California Building

| ITEM 2 | ACCESS |
| Matrix Adoption Tables, Chapters 1, 2 and 11A: Various sections | |

EXPRESS TERMS

FIGURE 11A-B: ELEVATOR CONTROL PANEL.

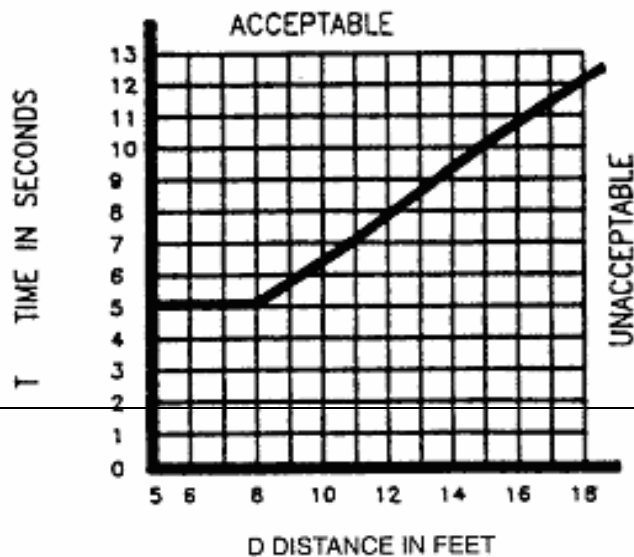
Omit Figures 11A-A, 11A-B and 11A-C below:
